DOCKET NUMBER 50-483
UNION ELECTRIC COMPANY
CALLAWAY PLANT
BDMS ELIMINATION

This amendment application would delete Technical Specification (TS) 3.3.9, "Boron Dilution Mitigation System (BDMS)," and its associated Bases. The BDMS, currently required by 10CFR50.36(c)(2)(ii) Criterion 3 for inadvertent boron dilution mitigation, would no longer be credited and the automatic valve swap-over function would be eliminated. Operational details associated with the revised analysis will be contained in FSAR Section 16.3.5 (e.g., one RCS loop must be in operation and two high VCT water level alarm channels must be operable).

**Appendix A - Safety Analysis of the Postulated Inadvertent Boron Dilution Event for
MODES 3, 4, and 5**

Figure VI-1 VCT Water Level Setpoints

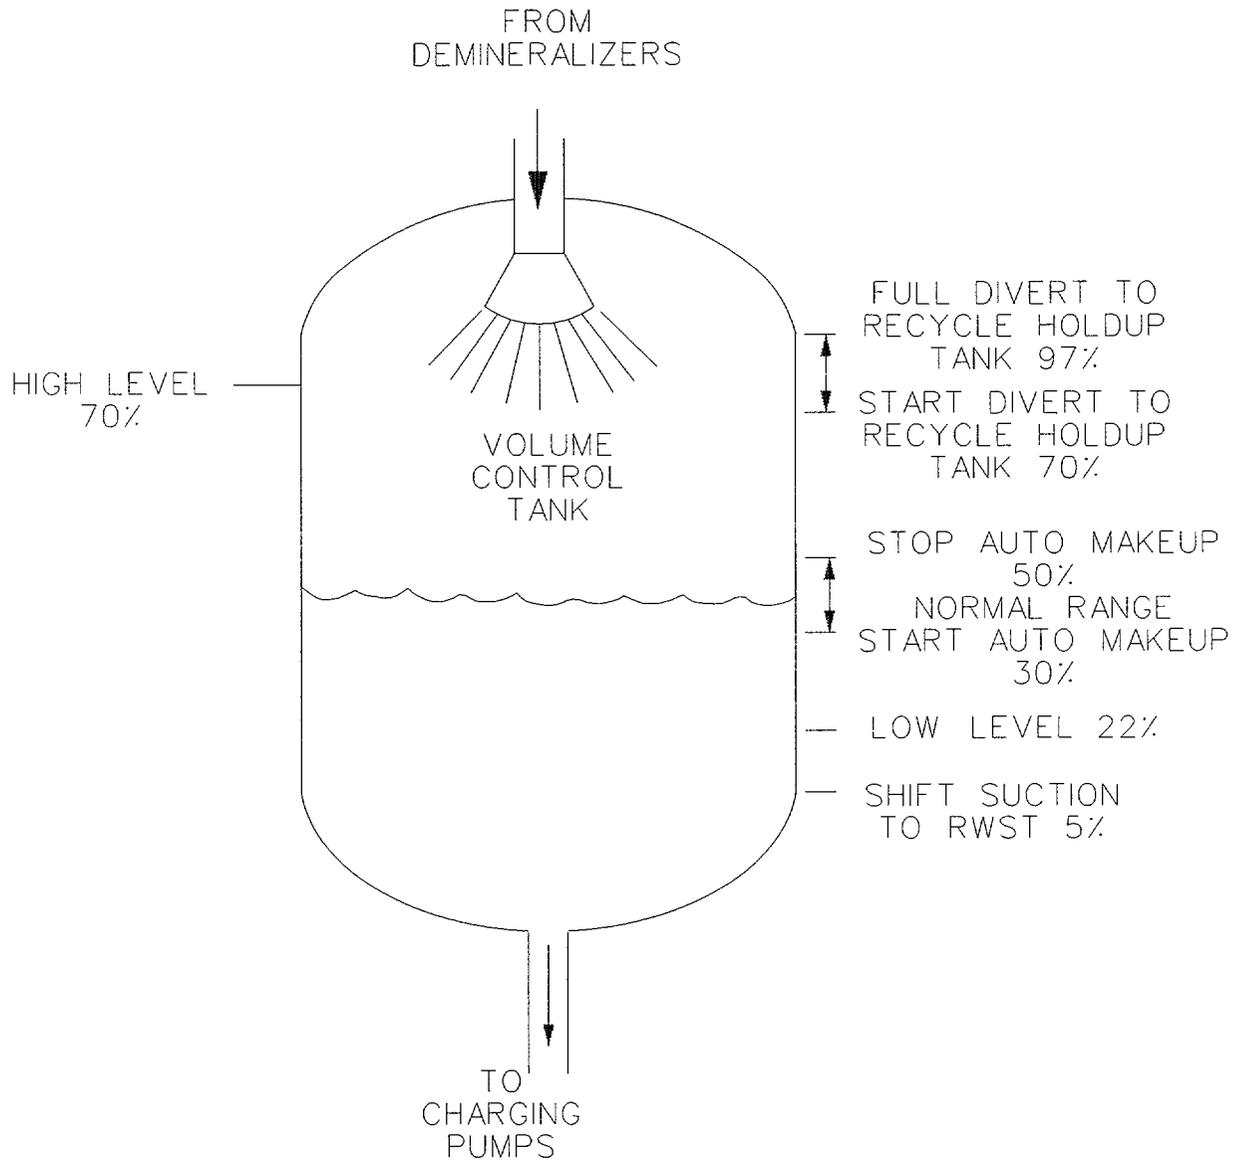
- Installation of two redundant alarms for high VCT water level on safety-related instrument loops BGL-0112 and BGL-0185. The setpoint for this function (70% of span) is credited in the analysis. This setpoint is lower than the current high VCT water level alarm setpoint on the non-safety instrument loop (BGLB0149A is set at 97% of span and will only be associated with the full divert to RHT alarm after modification completion) and greater than the "stop auto makeup" setpoint (50% of span).
